DEVELOPMENT REVIEW BOARD  
SUPPLEMENTAL SUBMITTAL

PROJECT NO. PR-2020-004820

**Re:** Hotel Circle Ramada Apartment Conversion DRB Comment Responses (PR-2020-004820)

**AS101**

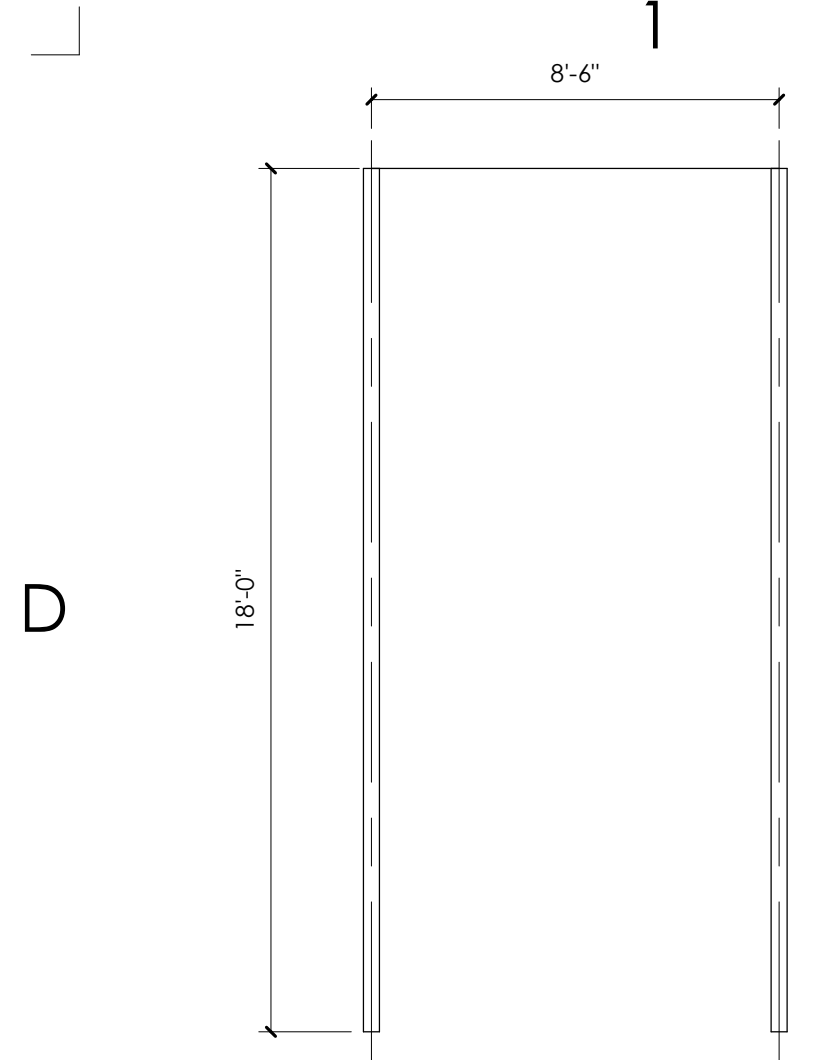
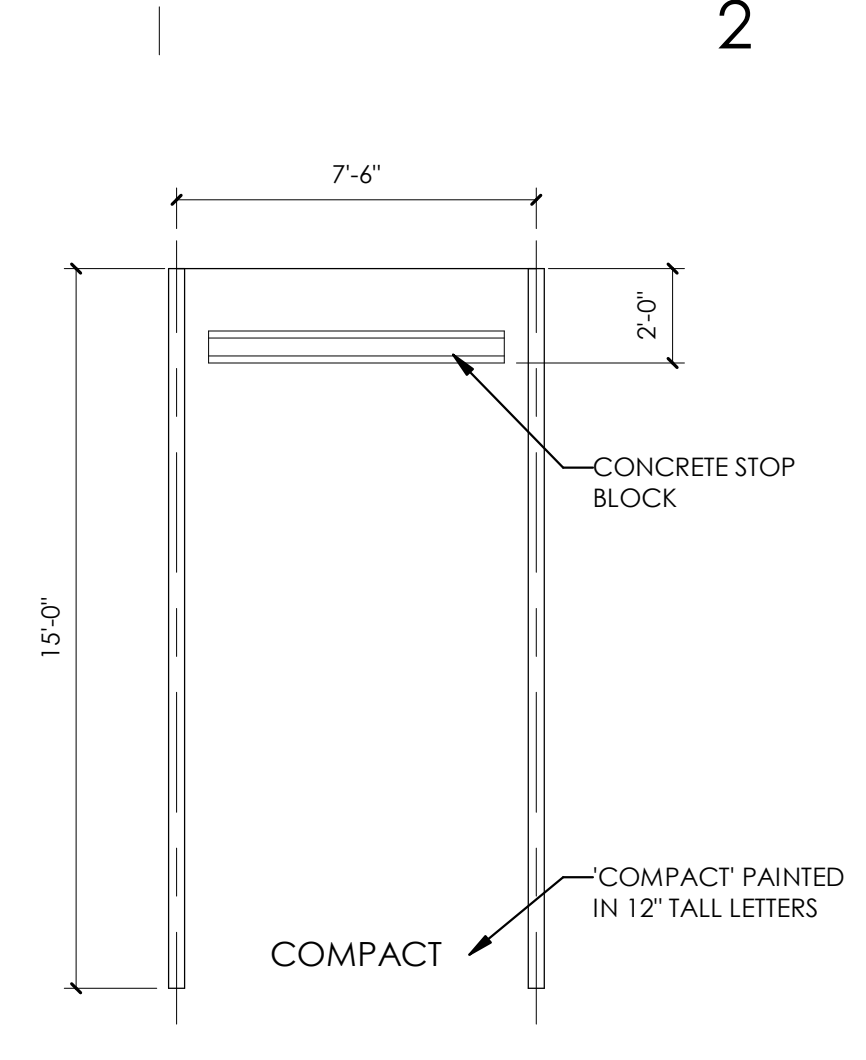
2. Define what will be done with the existing gate at the southern entrance. Sufficient emergency access shall be provided; receive Fire Marshall approval.

4. The minimum aisle width is 22 feet for an aisle that is not a main driving aisle. Label all driving aisle widths and show parking space dimensions. Call out curb and curb radii.

- a. ***Aisle widths and radii have been dimensioned on the updated site plan.***
5. Label clear sight triangles on the site plan. Provide standard note that defines limits of landscaping height on both the site plan and landscaping plan.

- a. ***Clear sight triangles have been identified with the required note added (Keynote #36)***
6. Show existing sidewalk width on Hotel Circle. The minimum sidewalk width required is 5 feet. Revise drive entrances to be ADA-compliant.

- a. ***The existing gate located at the back of sidewalk will be removed (Keynote #35). A Fire 1 plan is under review by the Fire Marshal.***
3. Make a distinction between new and existing parking lot infrastructure by use of a separate legend for new versus existing.

- a. ***Drive entrances and sidewalk have been updated to be ADA-compliant and add width to meet the 5-foot requirement (see Keynotes #13 and #26).***

- 24 EXISTING STRIPED NO PARKING ZONE TO REMAIN
- 25 EXISTING CURB AND GUTTER TO REMAIN
- 26 EXISTING PUBLIC SIDEWALK TO REMAIN - ADD 1' OF POURED CONCRETE SIDEWALK WHERE PRACTICAL TO PROVIDE A COMBINED SIDEWALK WIDTH OF 5 FEET.

- 35 EXISTING CRASH GATE AT SOUTH SITE ENTRANCE TO BE REMOVED.
- 36 MINI CLEAR SIGHT TRIANGLE AT EACH DRIVEWAY ONTO SITE. LANDSCAPING AND SIGNAGE WILL NOT INTERFERE WITH CLEAR SIGHT REQUIREMENTS. THEREFORE, SIGNS, WALLS, TREES, AND SHRUBBERY BETWEEN 3 AND 8 FEET TALL (AS MEASURED FROM THE GUTTER PAN) WILL NOT BE ACCEPTABLE IN THE AREA.

**B1 SITE - TYP. FLARED ADA CURB CUT**  
1/4" = 1'-0"

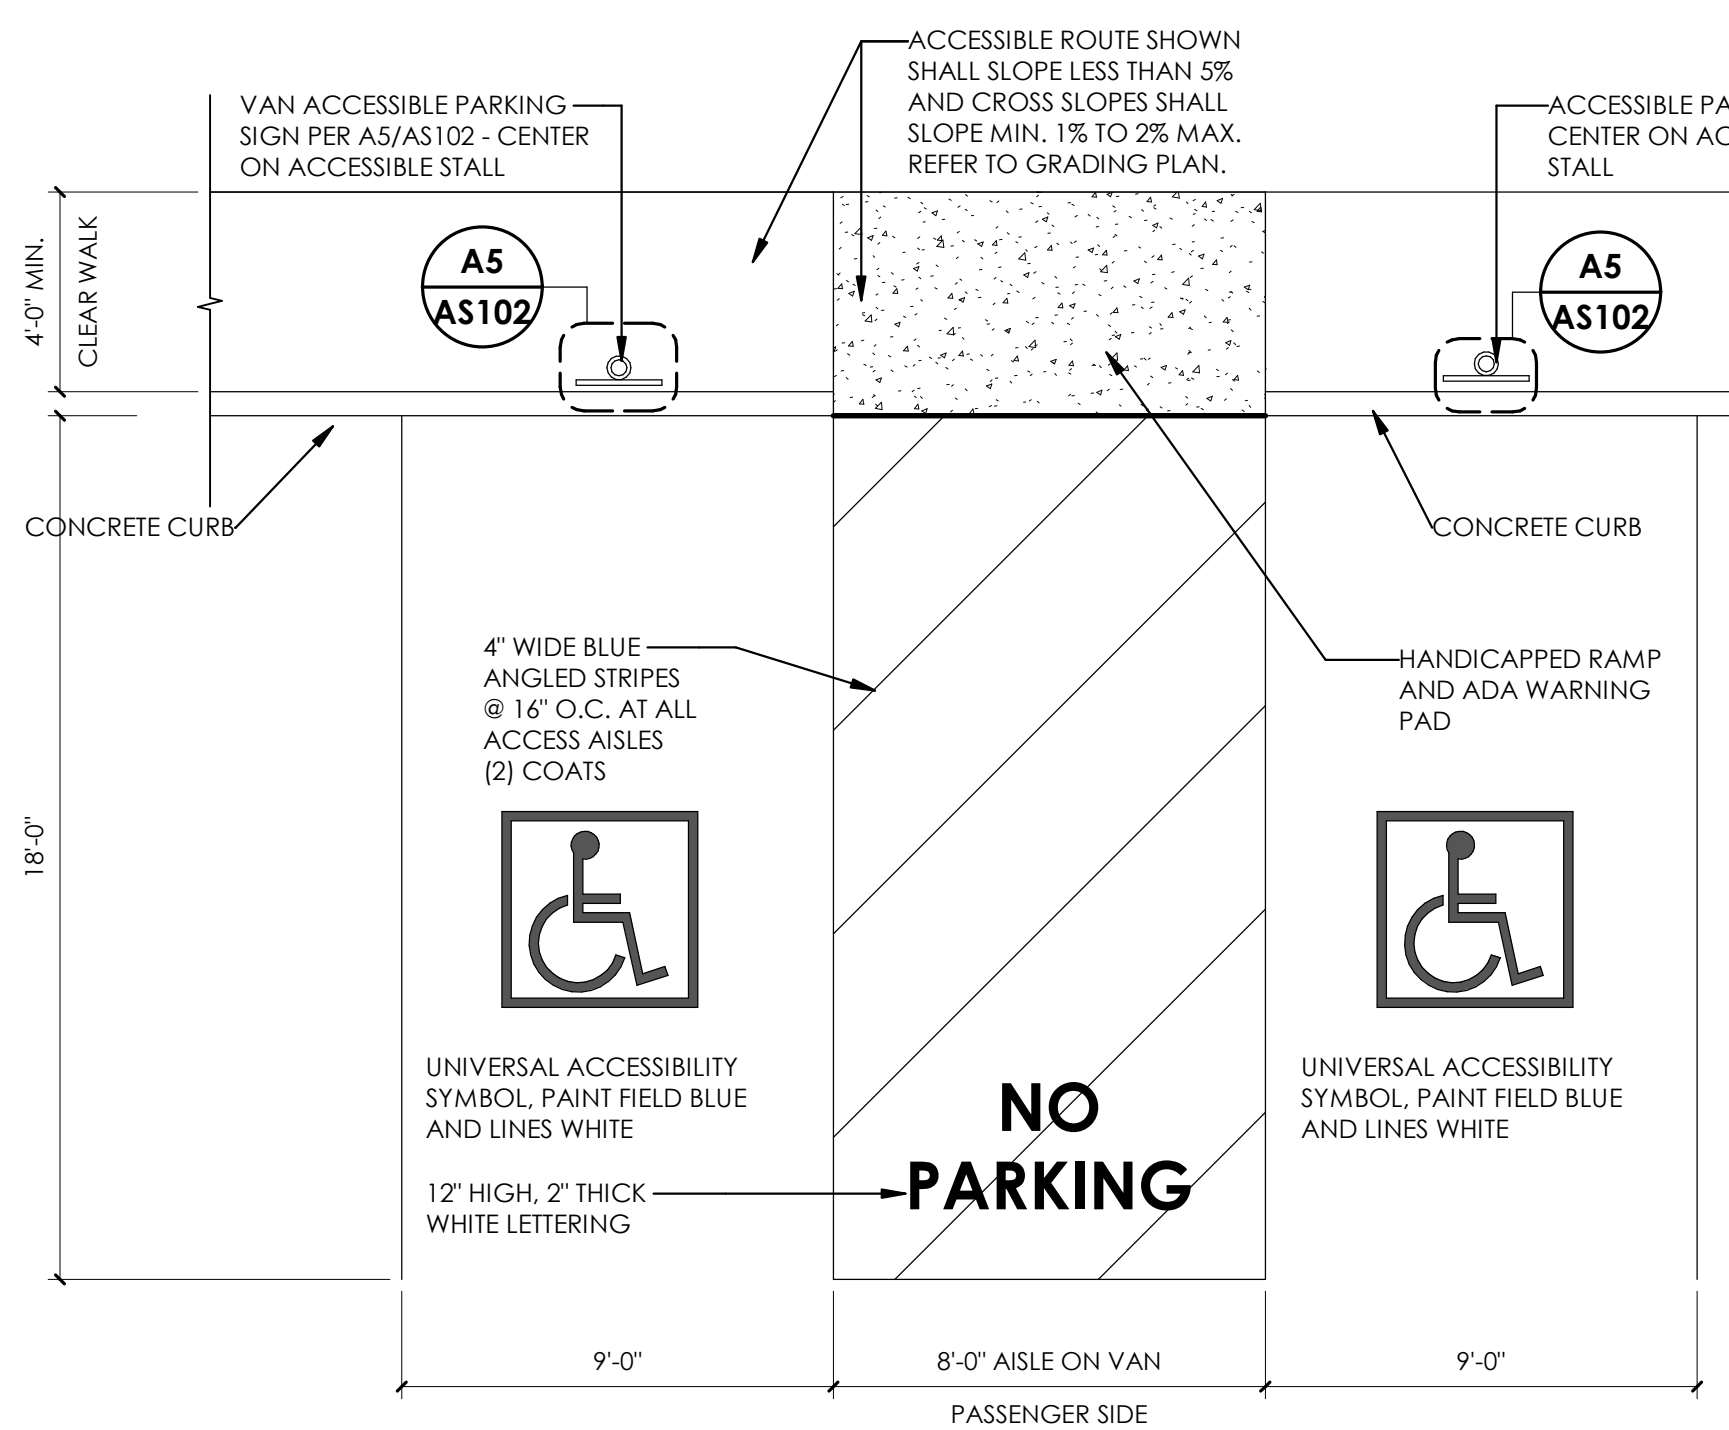
10. Provide details for the new curb, curb ramp, and sidewalk, and indicate a maximum 2% slope on the sidewalk. Curb should separate parking from sidewalks and landscape islands. Also show doorways to establish adequacy of pedestrian paths and ADA access. With notes, verify that any existing walkways establish a 6-foot ADA pathway to building and to right-of-way.

- a. ***See updated details on sheets AS102 and AS103, including sidewalk, curbs & gutter, and ramps. A 6-foot ADA pathway connecting the building to the public way is being created by this plan (see Keynote #30).***

**B2 SITE - TYP. VAN ACCESSIBLE ADA PARKING STRIPING**  
1/4" = 1'-0"

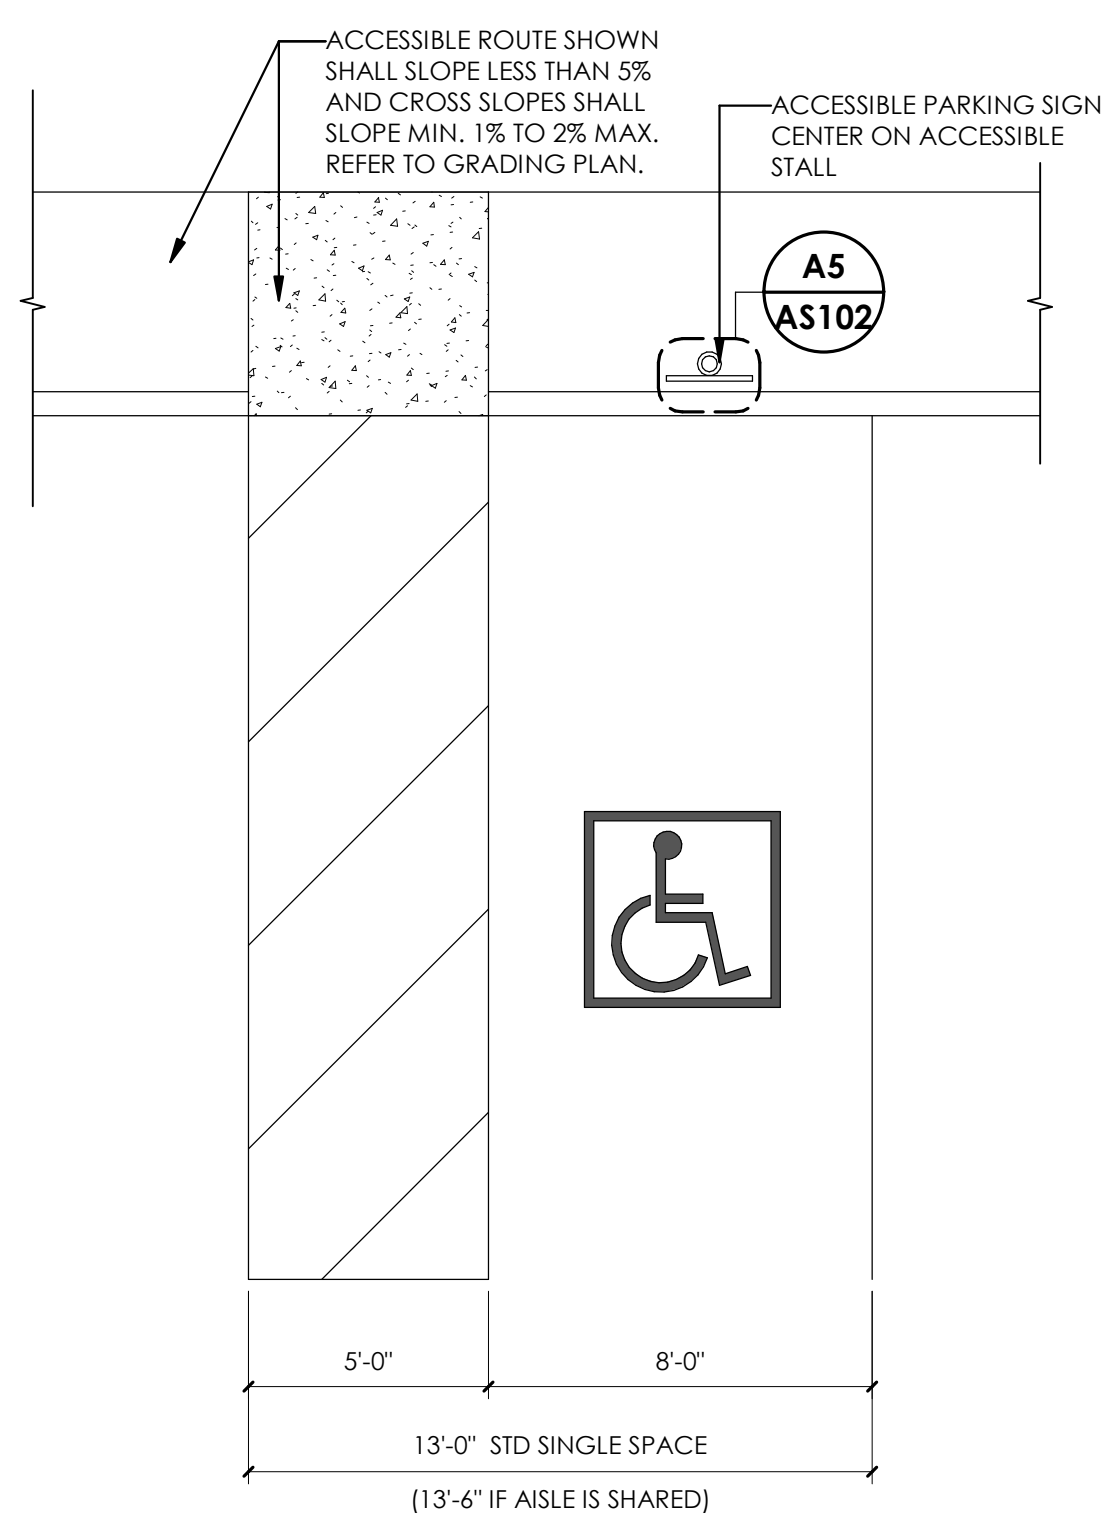
12. The van accessible aisle shall show "No Parking" at the back of the aisle.
  - a. ***Van accessible striping details, including the required "No Parking" text is shown on Sheet AS102.***

**A3 SITE - TYP. BIKE RACK**  
1/2" = 1'-0"

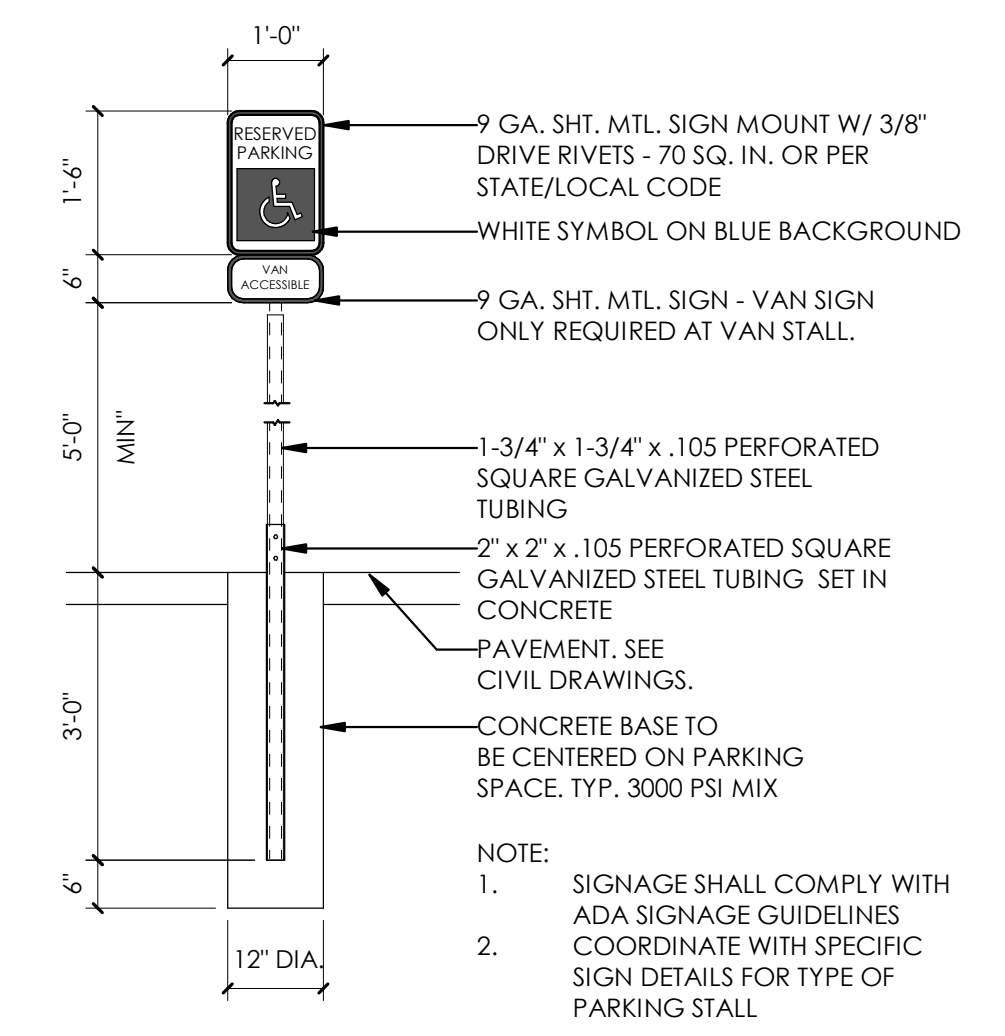
13. Bike rack shall follow dimensioning specified in the IDO.
  - a. ***Bike racks throughout the site have been spaced according to the IDO and DPM and detailed on sheet AS102.***
